Texas Water Development Board
Report #0604830579

Kenedy Brackish Desalination Plant
Historical Data Review and
Performance Evaluation

By:
Veolia Water

August 8, 2013

Figure 5-2 System Recovery Achieved for Train A, B, C, and D.

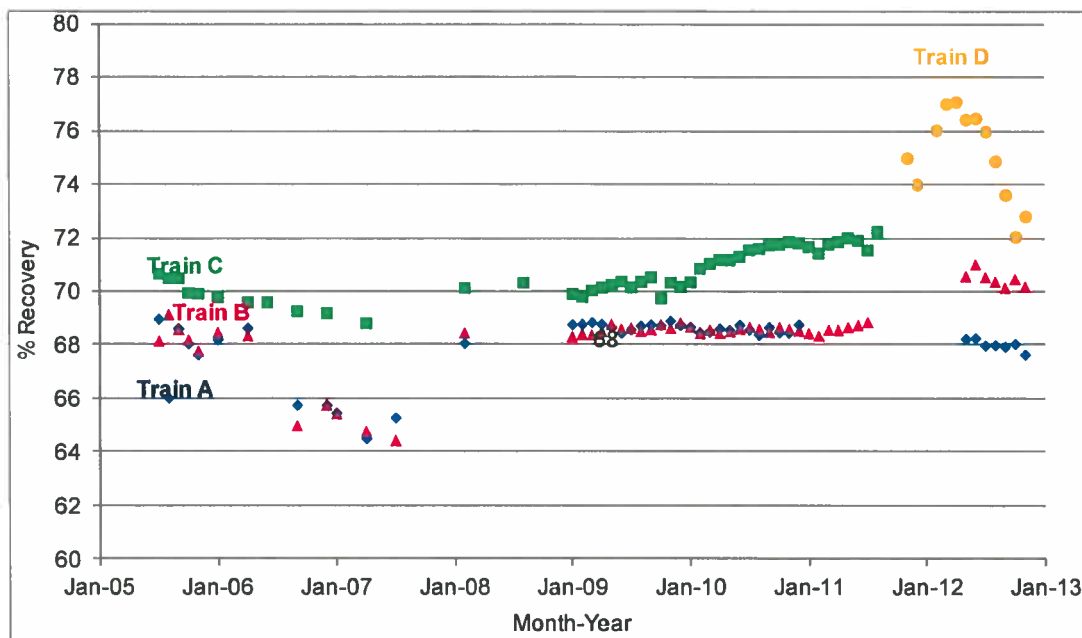
- b. Please explain why membrane replacement cost was not included in the Table.- **Costs included in appendix D.**
7. Section 5.1.1 – Figure 5-2 shows that recovery in Train C started increasing in January 2010. Please explain the reason. **The reasons for the increase is unclear but suggest that the permeate flow meter was not functioning correctly. Explained in first paragraph on page 18.**

8. Section 5.1.1 – Figure 5-2 shows that recovery in Train D was unstable the entire year of 2012. Please explain reasons for continued instability of recovery in Train D after start-up. **May have been due to the membrane fouling. Discussed in second paragraph on page 18.**

Figure 6-3 Cartridge Filter Replacement Quantities

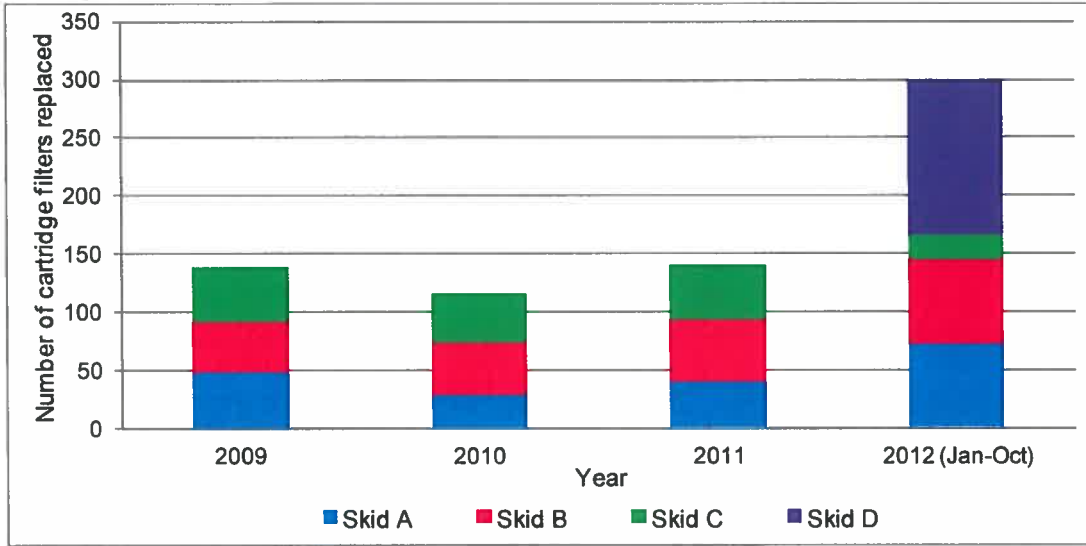
15. ☒ For Figure 6-3, please change "skid" to "train". Please also add labels or use hatching and remove legend. - **SARA does not have access to Veolia's figures, tables, nor graphs and cannot make updates to them. No updates received from Veolia.**

Figure 6-7 Power Costs per Thousand Gallons of Product Water: Train A vs Train D

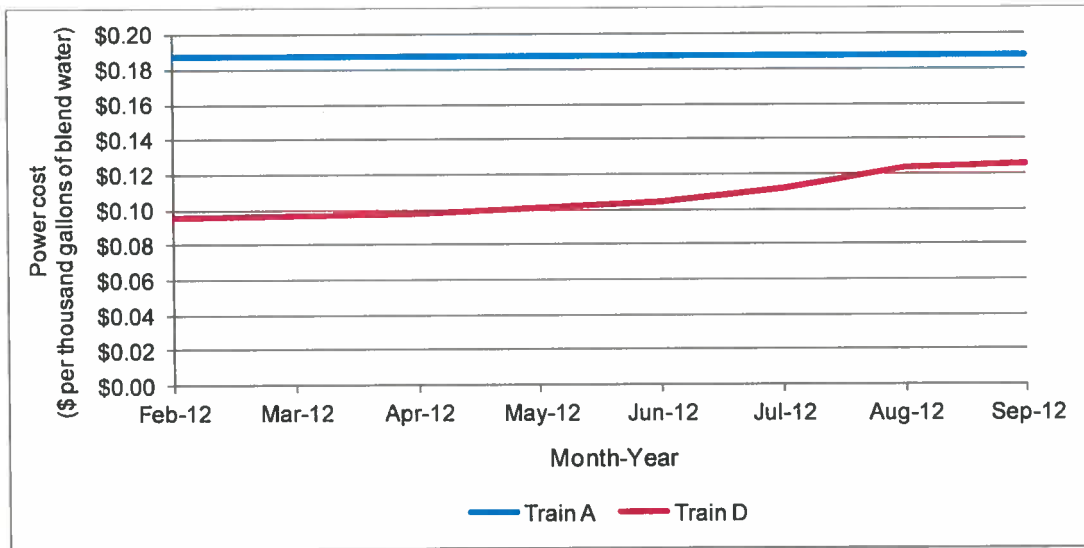
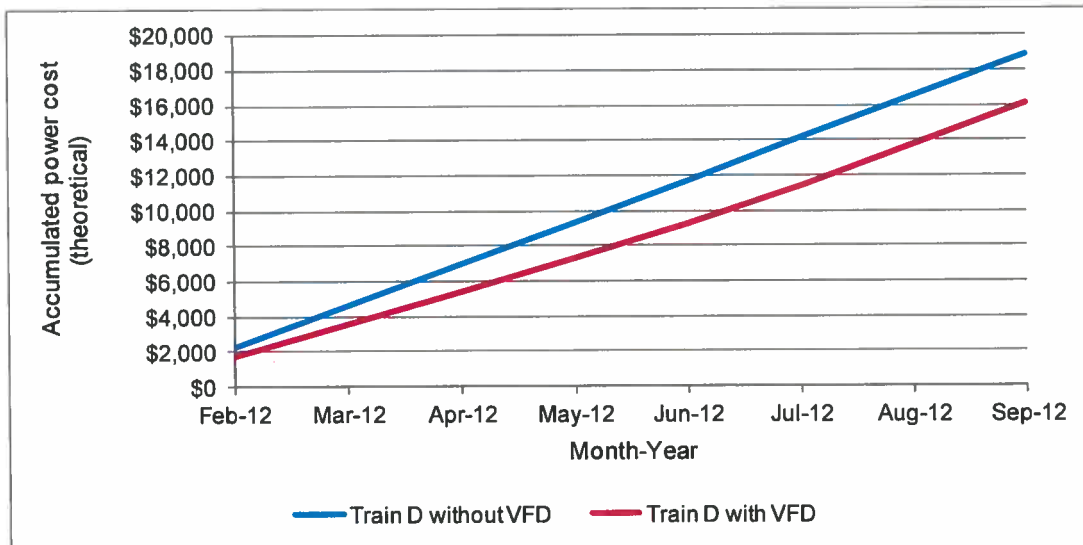
14. ☒ For Figure 6-7 and 6-8, please add labels to the graph and remove legend. If a reader prints black and white, the reader will not be able to differentiate between colors - **SARA does not have access to Veolia's figures, tables, nor graphs and cannot make updates to them. No updates received from Veolia.**
